**RE: 3.6 GHz band legislative instruments consultation**

In reviewing the papers, the SSWG wishes to draw to your attention to an apparent anomaly with the C-Band filter characteristics on Earth Station receivers in the *Radiocommunications Advisory Guidelines (Managing Interference from Spectrum Licensed Transmitters — 3.4 GHz Band) 2015* (paper RAG Tx 3.4 GHz).

Amended Table 1: Minimum frequency response of Earth receive station's RF filter

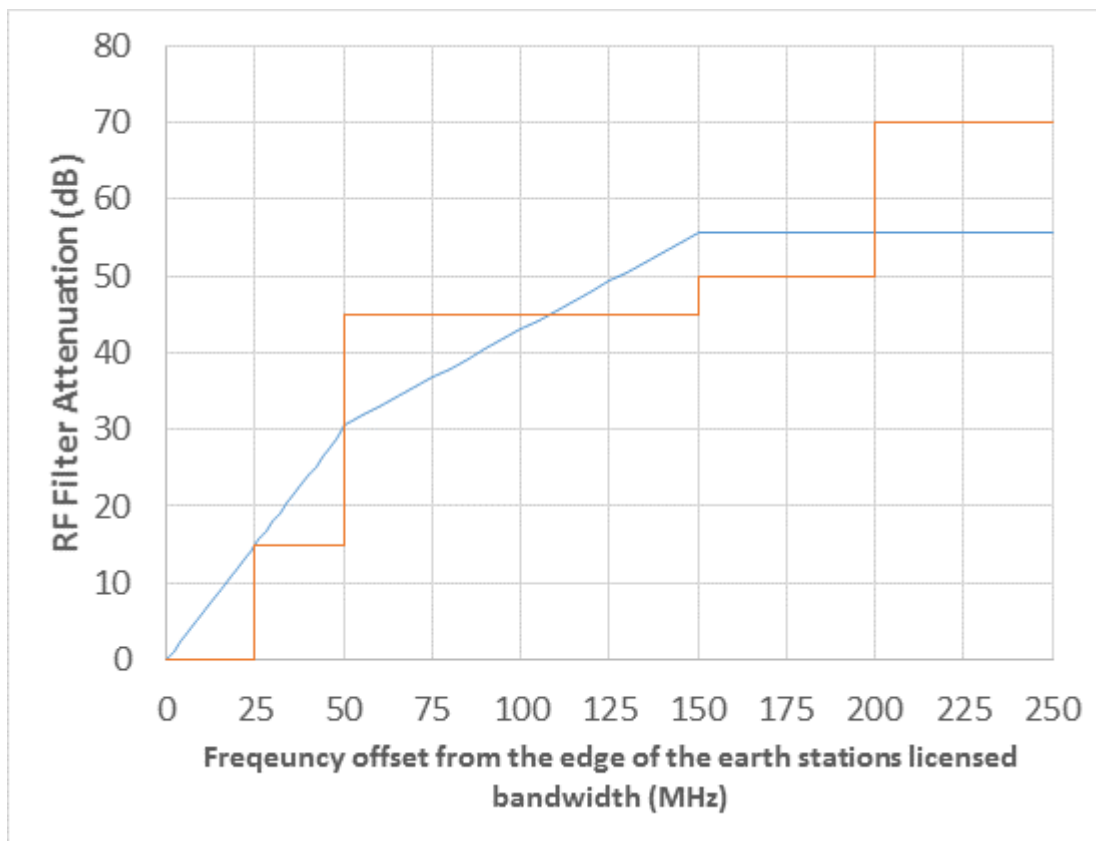
In Section 4.3 *Protection requirements – Earth receive stations operating in the 3600-4200 MHz band for fixed-satellite services*, the SSWG has identified an unexpected step function behaviour in Table 1. In reviewing this table Telstra has offered the following solution: in the second row of the table, 50 MHz should be subtracted from the offset value, given that row applies from 50 MHz to 150 MHz. If this amendment is made to the table, then the step function, with the unexpected steps at both 50 MHz and 150 MHz disappear, resulting in alignment with the FCC filter mask which was proposed by the ACMA in the TLG consultation (refer to page 34 of the TLG document Ver 4). The amended table and ensuing plot are attached to this letter. We understand that both Telstra and Foxtel will also be pointing this out in their submissions.

The SSWG also notes that the wording in the table heading 'Frequency offset (MHz) from the lower or upper frequency on the earth receive station licence' is not practical when there are multiple licences associated with the same Earth Station. The previous wording 'Frequency offset from lower edge of Earth station receiver (MHz)' in RAG Tx 3.4 GHz 2015 (and RALI MS39) is better, and in practical terms, these filters operate from the bottom of C-band either 3700 or 3800 MHz and are not generally tuned for a specific receive frequency.

Frequency offset (MHz) from the lower or upper frequency on the earth receive station licence	Rejection (dB)
$\leq 50$	$0.5 + 0.6 * f_{\text{offset}} \text{ (MHz)}$
$50 < f_{\text{offset}} \leq 150$	$30.5 + 0.25 * (f_{\text{offset}} - 50) \text{ (MHz)}$
$150 < f_{\text{offset}} < 200$	55.5
$\geq 200$	70

Orange line - RAG Tx 3.4 GHz Table 1  
 Blue line – Corrected Table 1, aligning with FCC mask
